FINAL
Phase 1 Treatability Study Report
Perchlorate in Groundwater
Baldwin Park Operable Unit
San Gabriel Basin

Prepared for
Baldwin Park Operable Unit Steering Committee

April 12, 1999

GAC/FB SYSTEM GENERAL ARRANGEMENT
Phase I Perchlorate Treatability Study

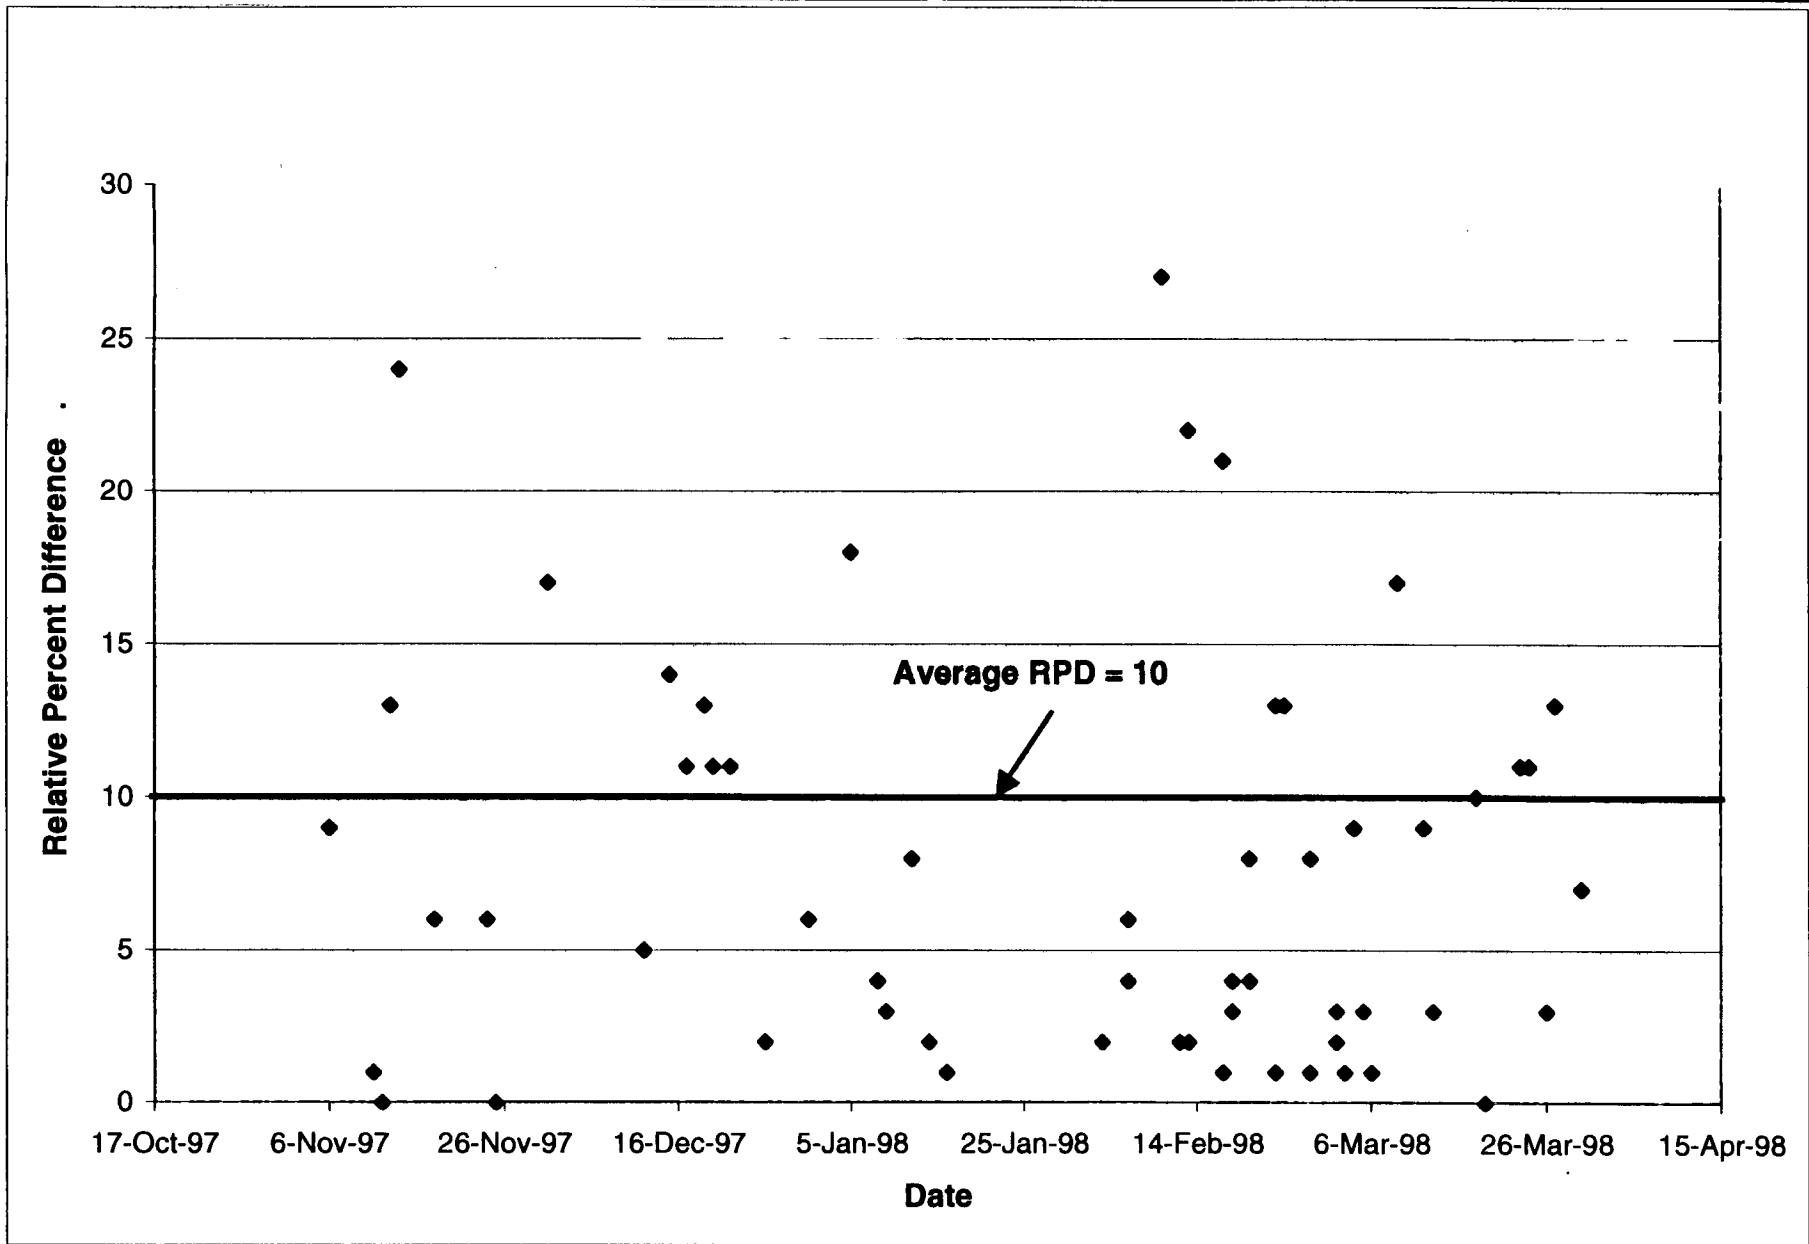
Baldwin Park Operable Unit Steering Committee Response to EPA Comments Phase 1 Treatability Study Draft Report		
Location	EPA Comment	Response
Plate 1	Plate 1 includes the statement "Confidential Business Information," yet we understand that the report has been distributed to several agencies and groups without specific instructions to keep any part of the report confidential. Please clarify whether the Steering Committee is claiming Plate 1 or any other part of the report as Confidential Business Information.	Aerojet is claiming Plate 1 as Confidential Business Information. Instructions for the Phase 1 report reproduction and distribution dictated that Phase 1 not be distributed to other agencies and groups. To assist in management if Confidential Business Information all copies of this report contain a blank sheet labeled as such. Plate 1 has been distributed separately to U.S. EPA and their consultant CH2M Hill.

6

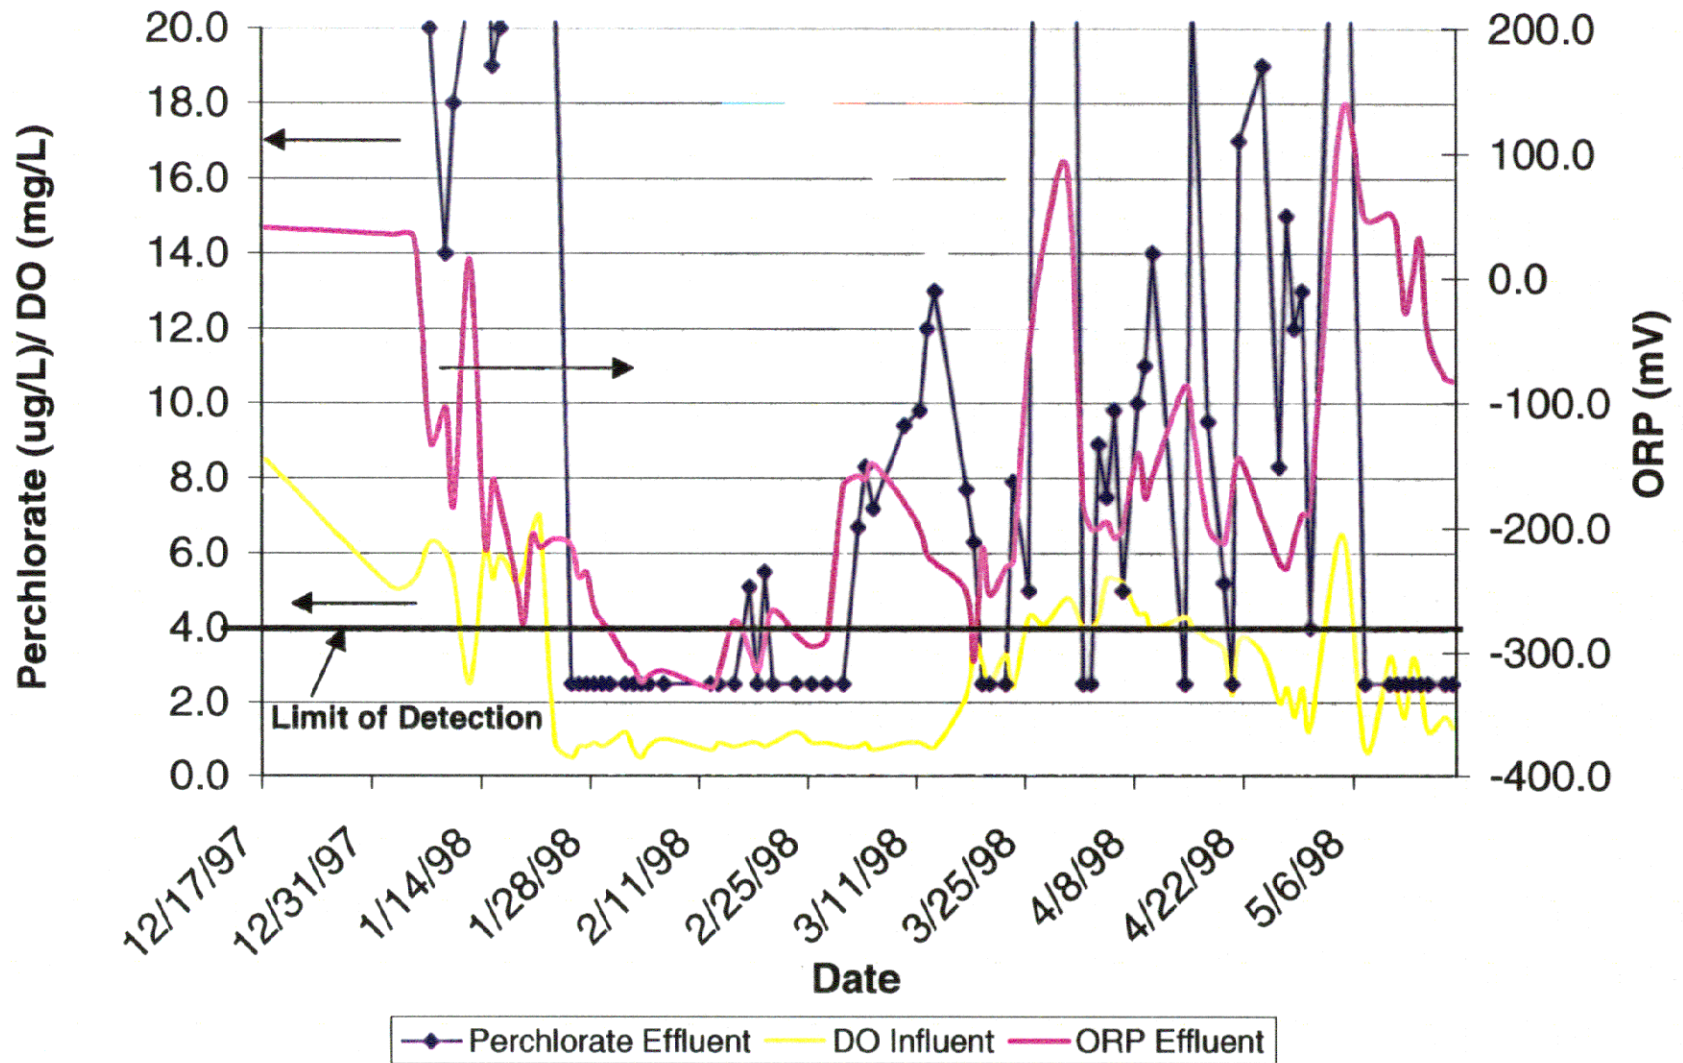
Table 3	We suggest adding a note specifying where the influent DO is measured. It appears that it was measured at port C, after internal recycle.
plate 6	For this and any other figures showing perchlorate concentrations near the detection limit, indicating the quantitation limit on the figure would help the reader correctly interpret the data (i.e., the perchlorate concentration did not necessarily stabilize at 4 ug/l).
page B-1, 3 rd bullet	In the 5 th line, eductor is misspelled.
page B-2, 1st bullet	In the 6 th line, the word "of" is missing.
page C-2, ¶ 4	Some words appear to be missing from the last sentence.
page C-4, ¶ 3	In the 1 st line, should the sentence be corrected to state that the ORP decreased (rather than rose)?
page C-4, ¶ 5	The last line in the paragraph states that the DO was reduced to a range of 9.5 to 1 mg/L. Should the 9.5 mg/L be 0.95 mg/L?

Plate 6	For this and any other figures showing perchlorate concentrations near the detection limit, indicating the quantitation limit on the figure would help the reader correctly interpret the data (i.e. the perchlorate concentration did not necessarily stabilize at 4 µg/L).	A quantitation limit for perchlorate has been added to the appropriate figures.
Page B-1, 3 rd bullet	In the 5 th line, eductor is misspelled.	The text has been changed to: The oxygen generation system, bubble contactor, and eductor will not be used during this study.
Page B-2, 1 st bullet	In the 6 th line, the word "of" is missing.	The text has been changed to: However, the groundwater well flow rate was

5-1

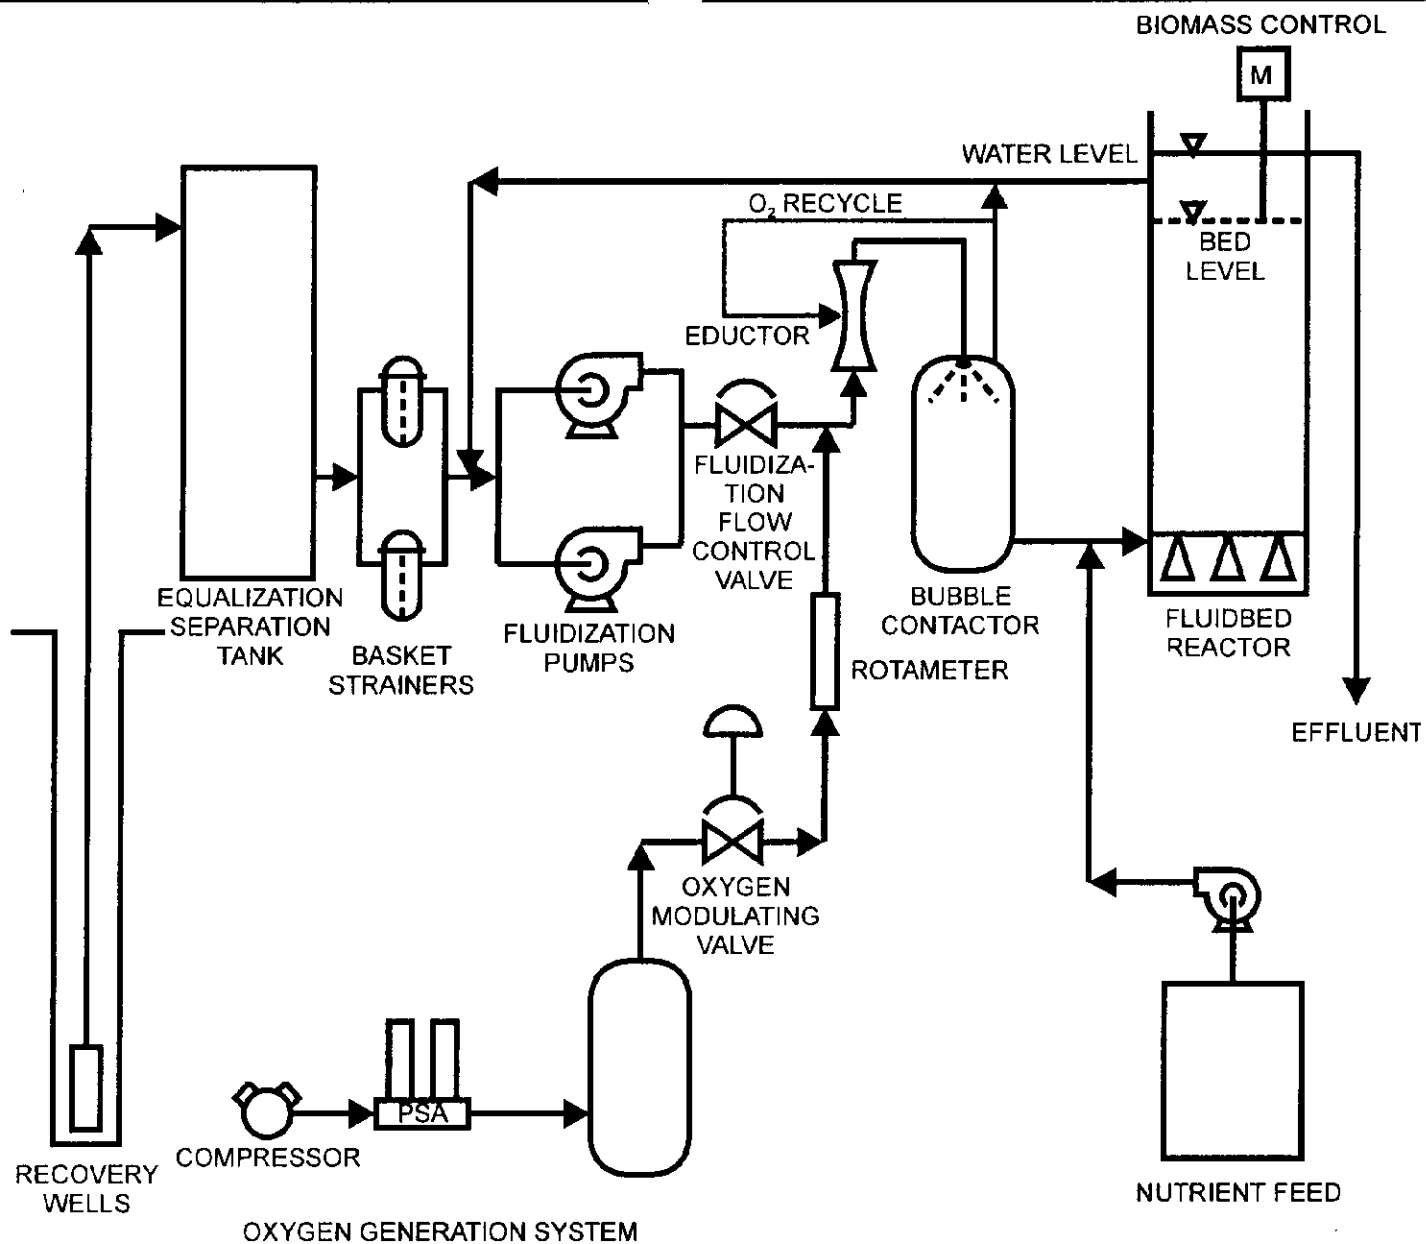
Comment: Figure 5-1 The photograph of the pilot unit shows an air compressor, oxygen generator, bubble contactor, and dissolved oxygen control meter. Presumably, these will not be used during the treatability study.

Response: The photograph of the pilot unit was provided by the vendor. This photograph includes system components that may or may not be used in this pilot study. Specifically the GAC/FB bioreactor will not contain an air compressor, oxygen generator, or bubble contactor. In line meters, placed in the bioreactor influent and effluent lines will measure dissolved oxygen, pH, redox potential, and temperature.

5-2

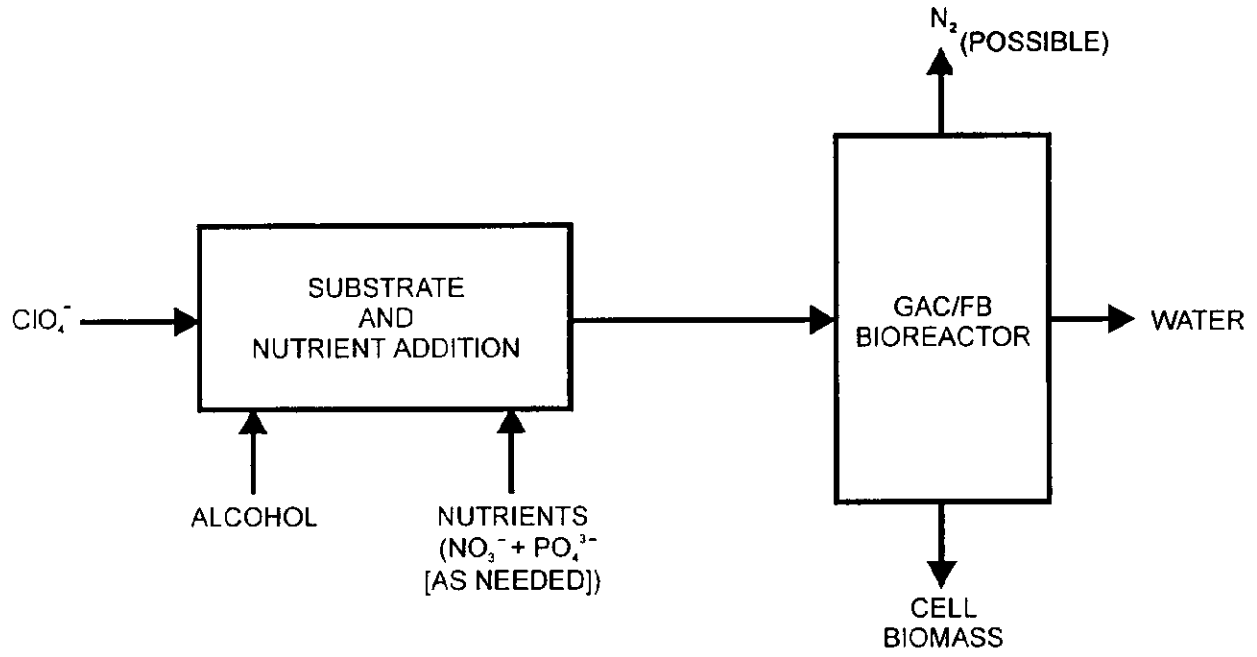
Comment: Figure 5-2 The Process and Instrumentation Diagram also shows an Oxygen Generation System and recycling line. Please correct the diagram or explain the need for this equipment. Also, please add other system components described elsewhere in the workplan (e.g., air stripper, filters, effluent pumps, recycle line, backwash line, backwash pumps, effluent equalization tank, 20,000 gallon storage tank, sample ports).

Figure 5-2 shows an equalization separation tank on the influent line. What is the purpose of this tank?

Comment: 11/1/7.1 *The workplan states that DO concentrations in the influent and effluent of the GAC/FB system will be monitored daily. We assume that these measurements will be made at sample ports located on the influent and effluent lines immediately adjacent to the reactor vessel. Please show the locations of the recycle line and sample ports on Figure 5-2.*

Response: The Process and Instrumentation Diagram (P&ID) for the pilot unit is a general P&ID and was provided by the vendor. This P&ID includes system components that may or may not be used in this pilot study.

Response: The Process and Instrumentation Diagram (P&ID) for the pilot unit, as shown in Figure 5-2, was provided by the vendor. This P&ID includes system components that may or may not be used in this pilot study and does not detail sample port locations. During bioreactor construction sampling valves that withdraw water from the influent and effluent lines will be added and sampling devices that withdraw water from positions that are approximately 25 %, 50 %, and 75 % through the reactor flow path will be added.

Figure 1. Alternate Arrangement of Unit Processes for Phase 2 Testing

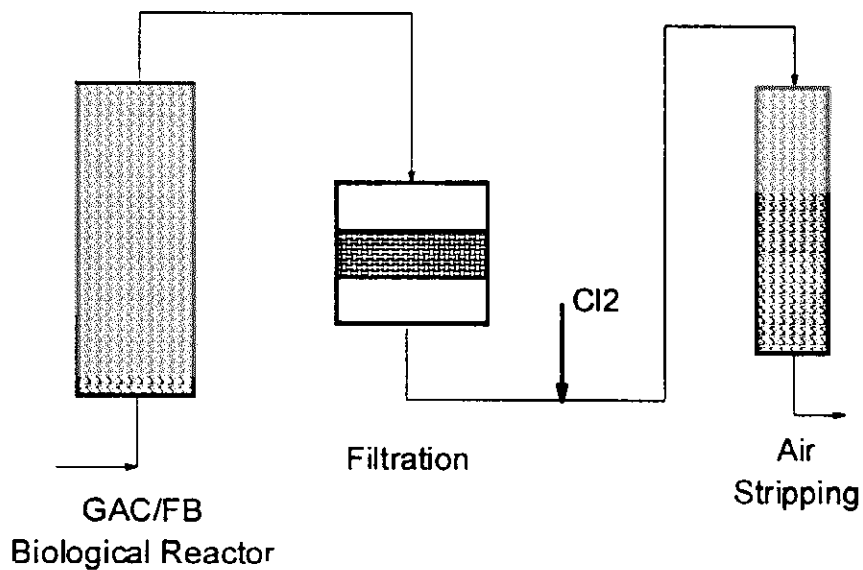
Should the DBP tests prove to be satisfactory, I recommend that an alternate arrangement of unit processes be considered. Figure 1 below shows the filtration process following immediately after the biological reactor with chlorination (or disinfection) following after that and preceding the air stripper. This arrangement will allow further removal of organics on a biologically active filter (an oxygen source may have to be added prior to filtration). In addition, the majority of the particles will be removed prior to chlorination which should improve the chlorination process significantly (lower dose, less contact time to get equivalent kill).
